SUBJECT:  
Perry Nuclear Power Plant  
Docket No. 50-440, License No. NPF-58  
Mid-Cycle Revision to the Core Operating Limits Report for Operating Cycle 19

**CORE OPERATING LIMITS REPORT FOR THE PERRY  
NUCLEAR POWER PLANT UNIT 1 CYCLE 19  
(RELOAD 18)**

Rev. 32 - Updated to incorporate the required SC 21-04 adjustments to the power dependent PROOS Operating Limit MCPR ( $K_p$ ) as identified in Obligation 23.

**Figure 3.2.2-3  
Power Dependent MCPR Limit (MCPR<sub>p</sub>)  
Pressure Regulator Out of Service**

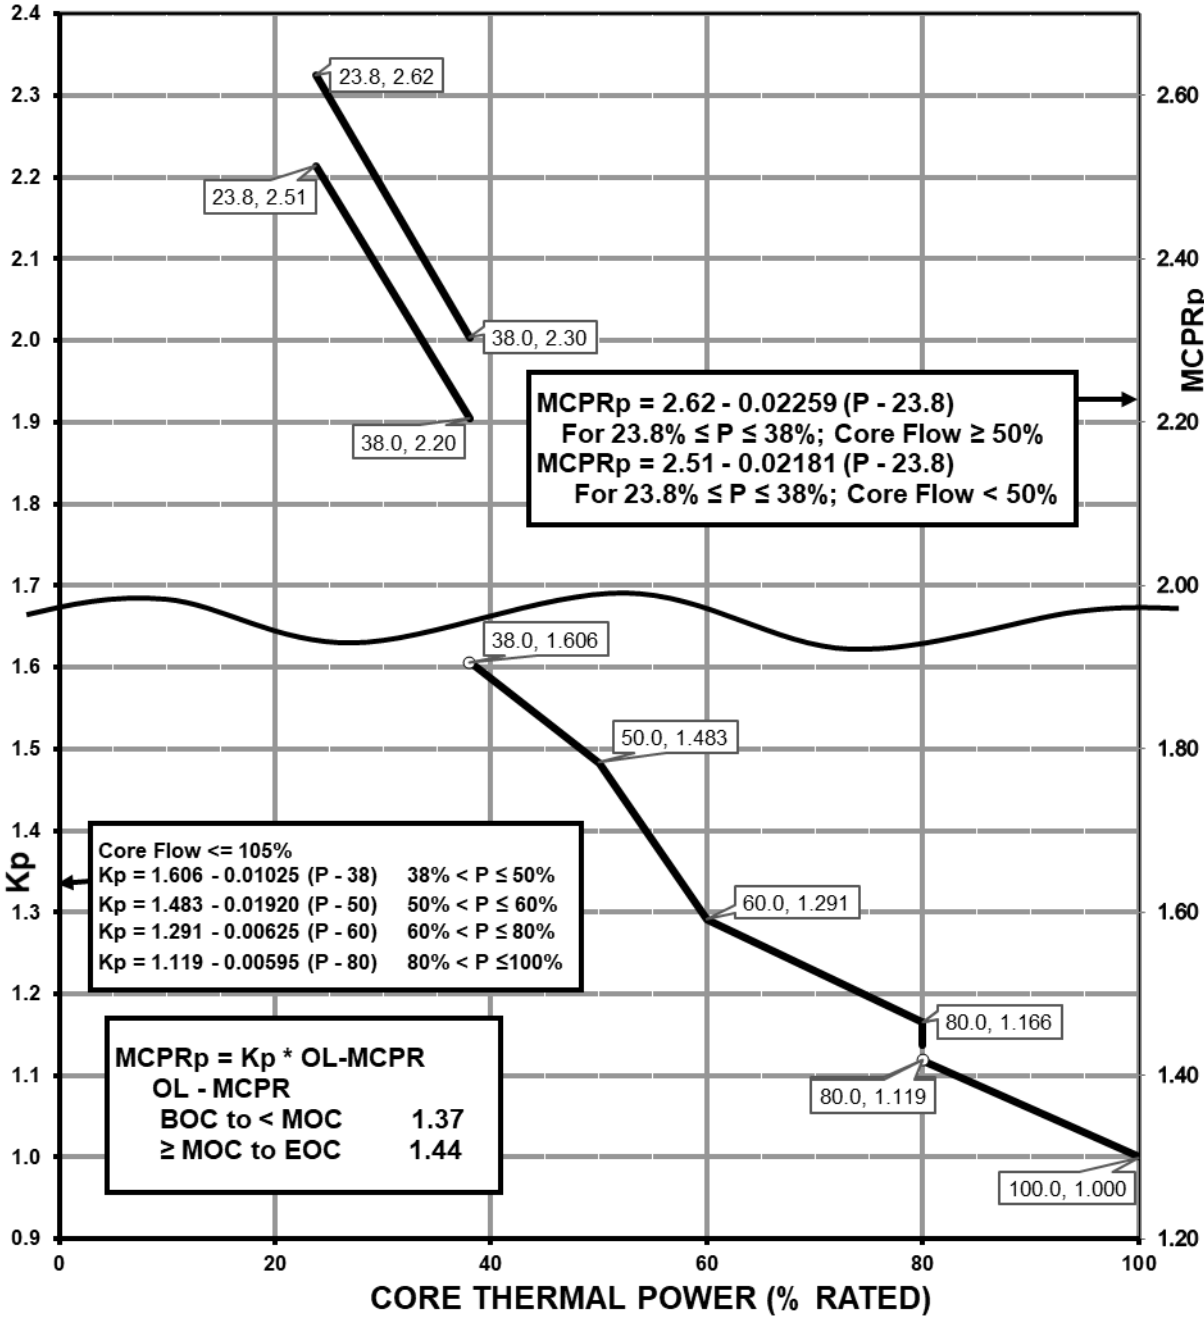
Figure 3.2.2-3, Power Dependent MCPR Limit (MCPR<sub>p</sub>) Pressure Regulator Out of Service, reflects the results obtained from the Cycle 19 specific PROOS analysis (Obligation 23) as adjusted by SC 21-04 Revision 1.

1. Revised Figure 3.2.2-3, Power Dependent MCPR Limit (MCPR<sub>p</sub>) Pressure Regulator Out of Service
2. Added Obligation 23 as the new report providing the MCPR<sub>p</sub> limits ( $K_p$ ) for PROOS.
